RS-18-143

Subject: Supplemental Information Supporting License Amendment Requests for Approval of Changes to Emergency Plan Staffing Requirements

SUMMARY OF CHANGES TO STANDARIZED EMERGENCY PLAN EP-AA-1000

Figure B-1a: Exelon Overall ERO Command Structure

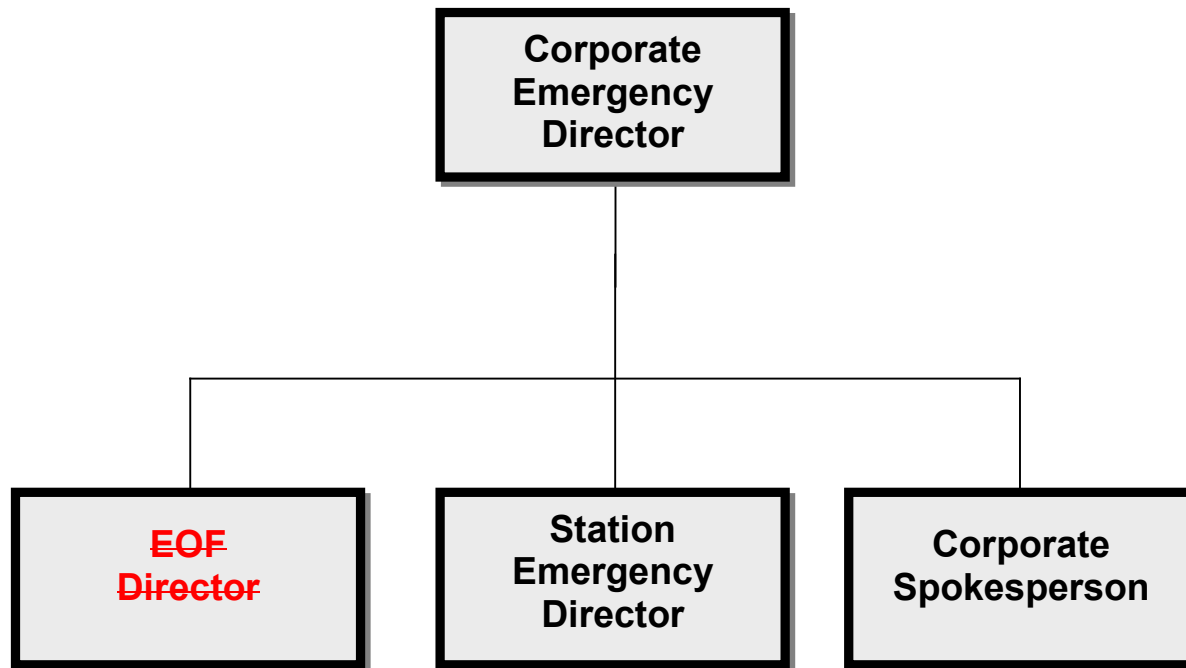
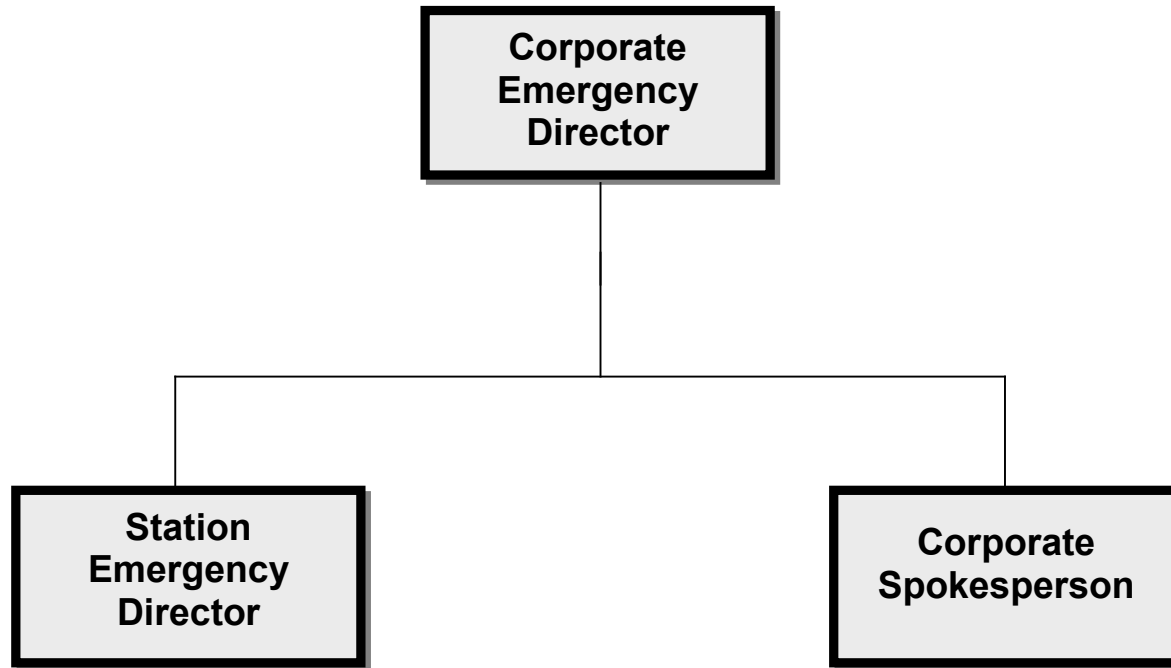
Since the initial submittal of the LARs for the Midwest and Mid-Atlantic sites (References 1 and 2), the NRC issued updated ERO staffing guidance as noted in its June 12, 2018, letter to the NEI, *"Alternative Guidance for Licensee Emergency Response Organizations."* Exelon is updating the EP-AA-1000, Appendix 5, Table 5-1 for the Midwest and Mid-Atlantic sites' LARs (References 1 and 2) to align with the June 12, 2018, updated guidance. Specifically, the specified staffing for the On-Shift Repair Team and the On-Shift Repair Team Supervisor functions are annotated as N/A. Exelon's "redline" and "clean" versions for those functions are updated and annotated as "N/A."

Figure B-1b: Emergency Onsite Organization

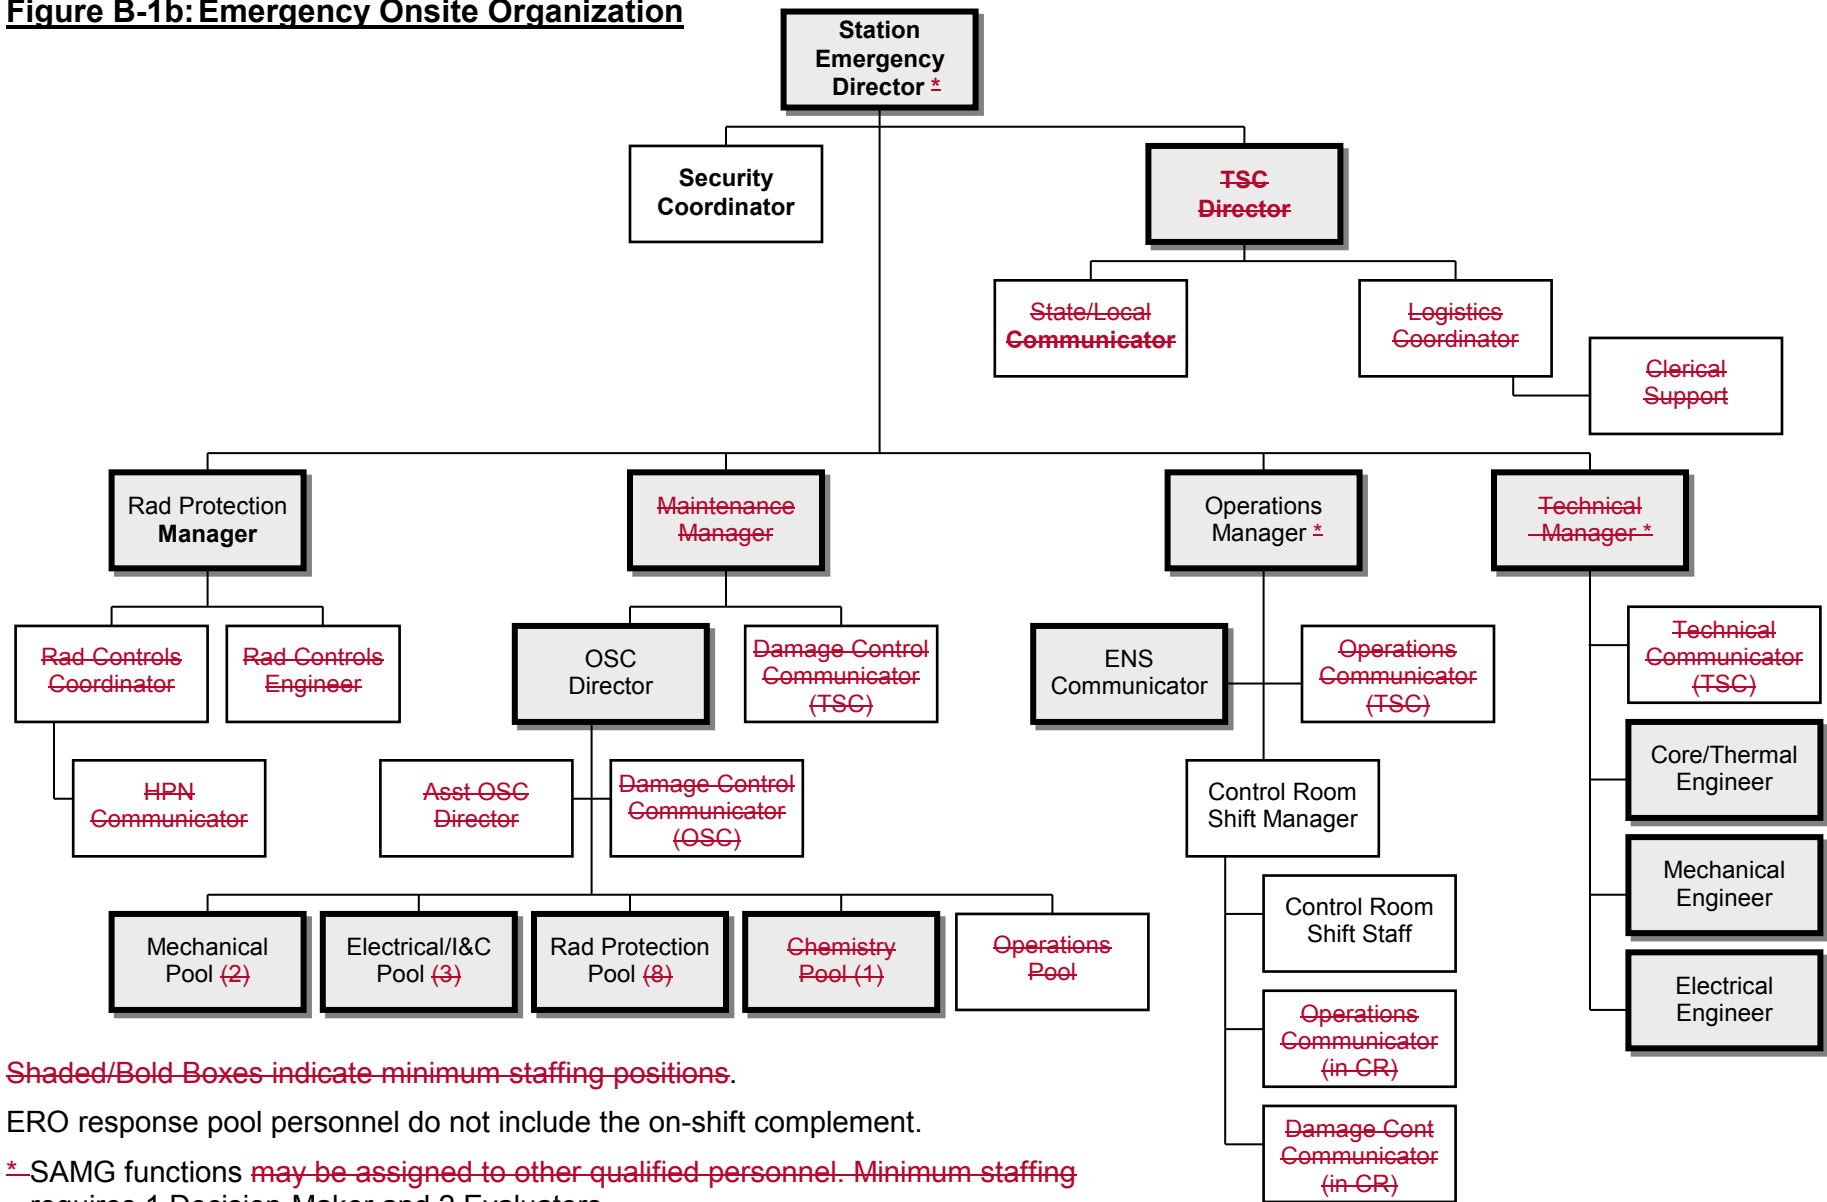
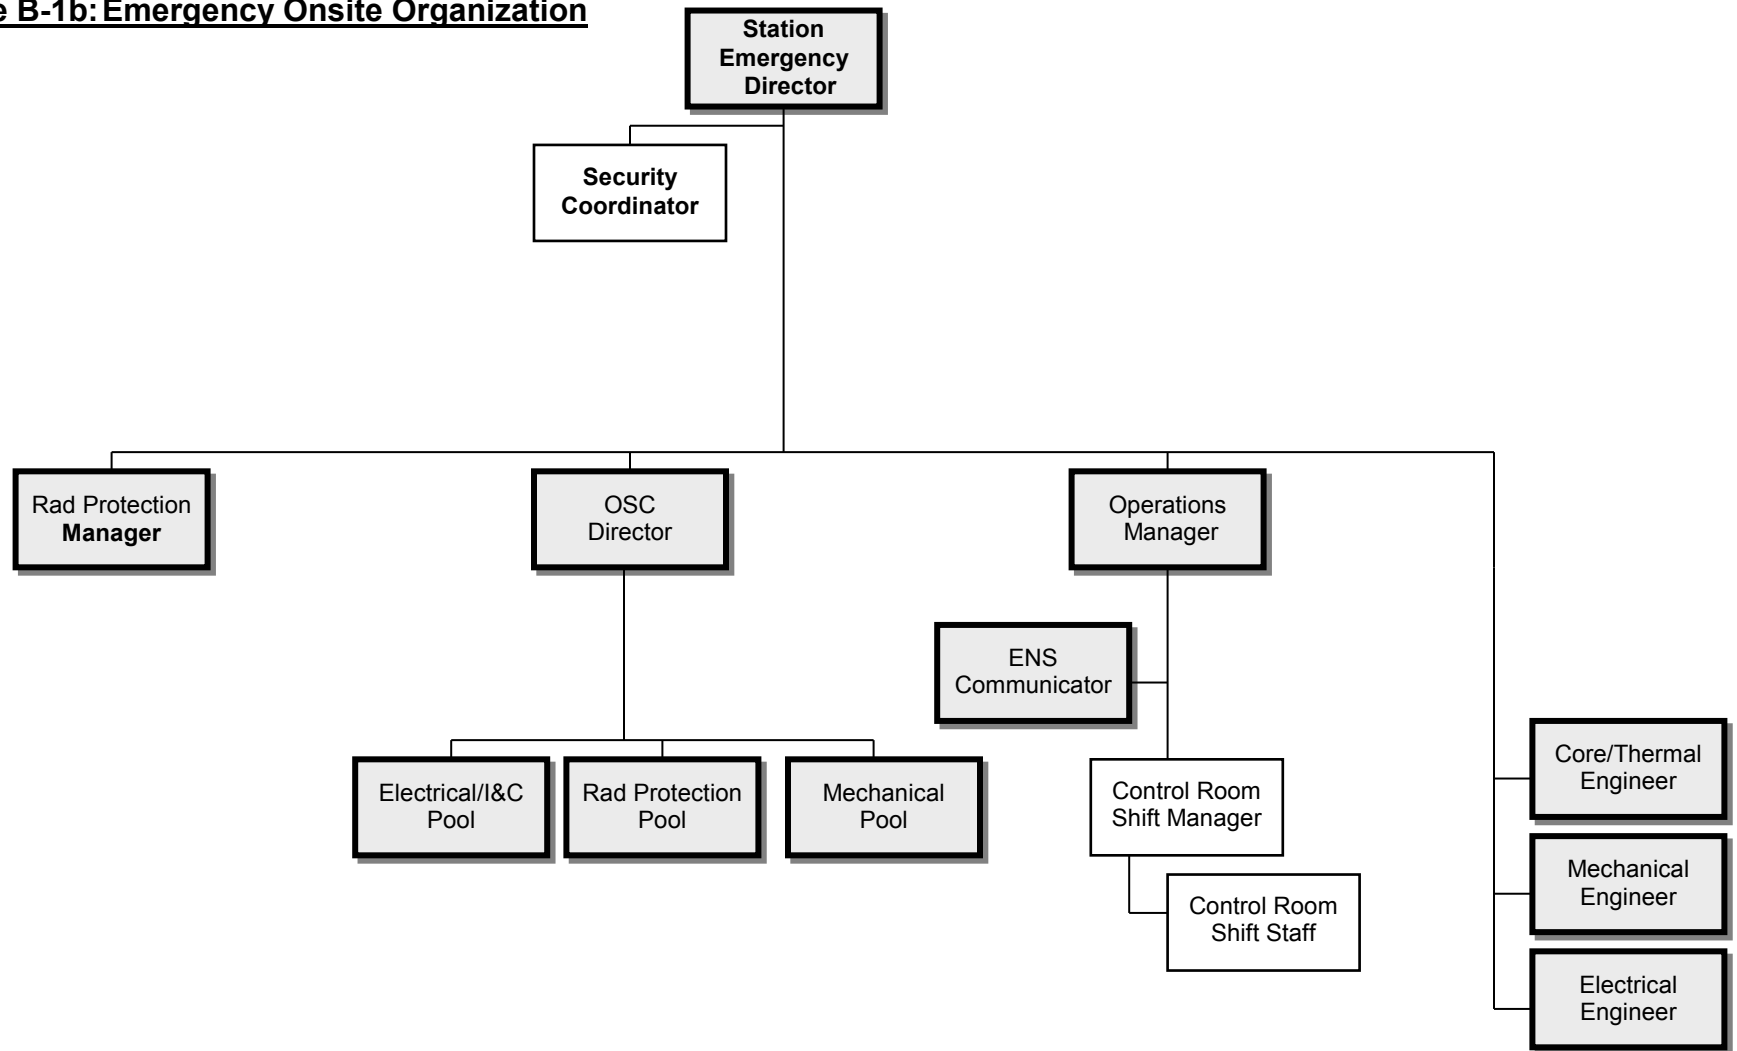
*-SAMG functions may be assigned to other qualified personnel. Minimum staffing requires 1 Decision-Maker and 2 Evaluators.

SAMG functions requires 1 Decision-Maker and 2 Evaluators.

Figure F-1: Exelon Notification Scheme (For Full Augmentation)

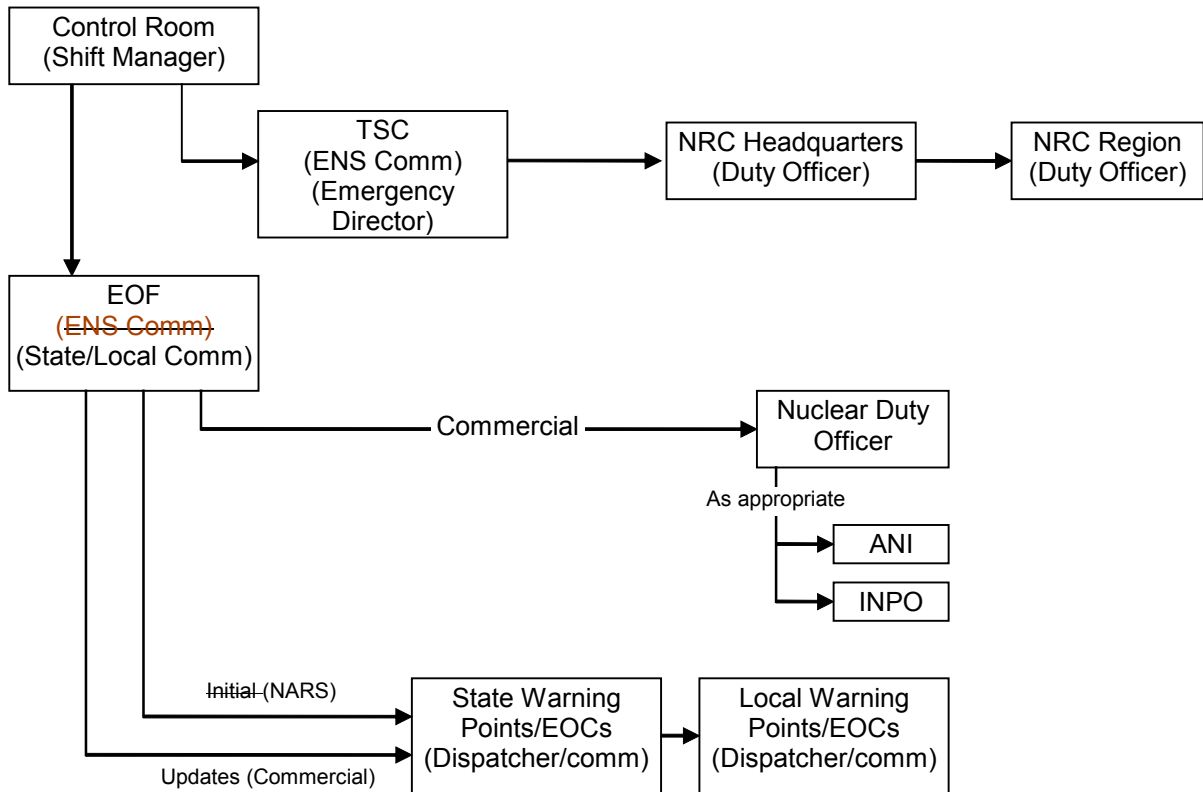
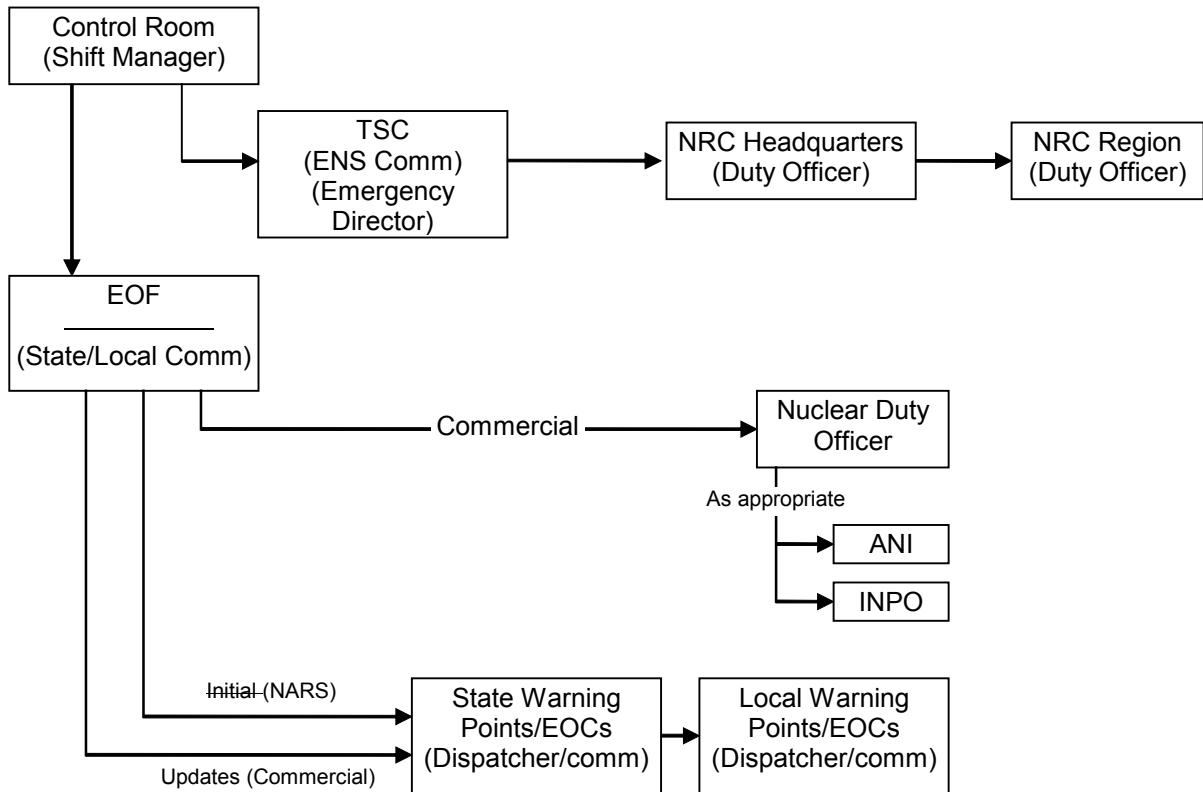
13. Section F, Figure 1 - This step was revised to delete reference to EOF Emergency Notification System (ENS) Communicator, since the ENS communicator is no longer staffed at the EOF under the proposed ERO staffing changes.

Figure F-3: NRC Communications for Nuclear Response

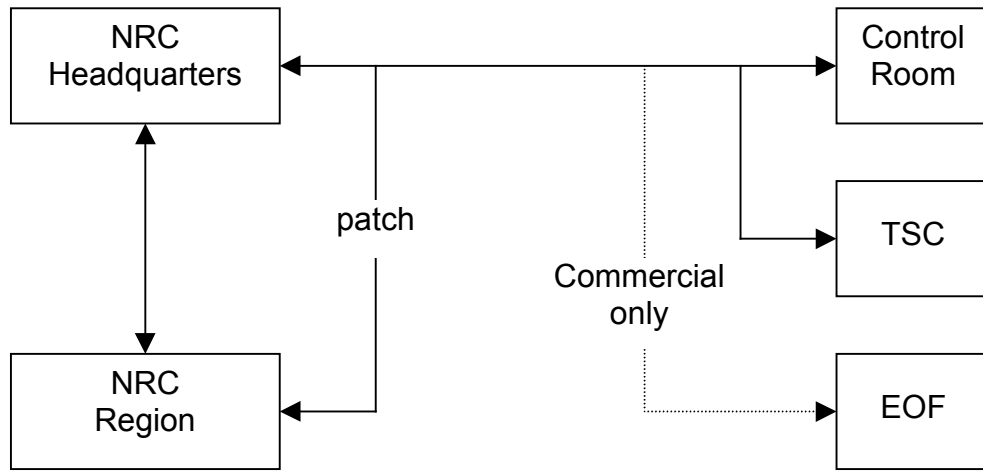
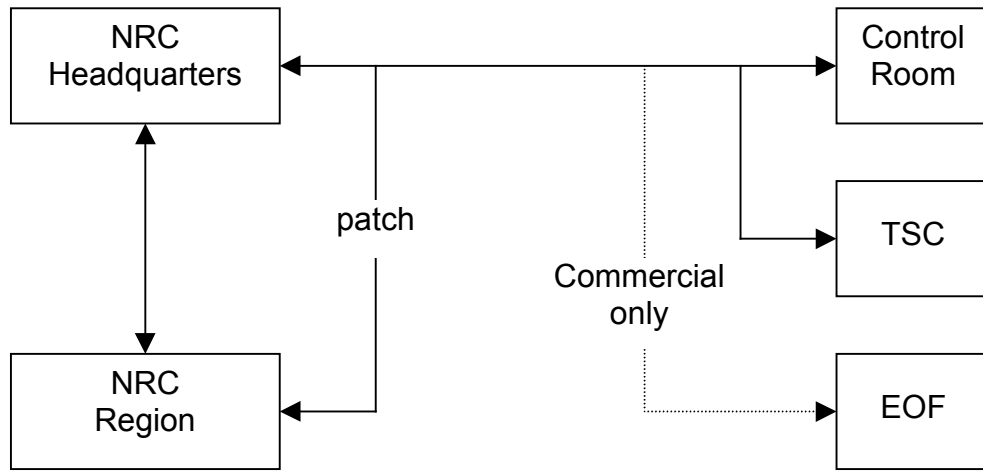
~~Health Physics Network (HPN): There also exists a separate dedicated telephone between the NRC, the TSC, and EOF for conveying health physics information to the NRC as requested or as an open line.~~

NOTE: ENS and HPN circuits may use the Federally maintained system, company tie lines or PBX as dedicated primary communications systems and have commercial backups.

NOTE: ENS circuits may use the Federally maintained system, company tie lines or PBX as dedicated primary communications systems and have commercial backups.
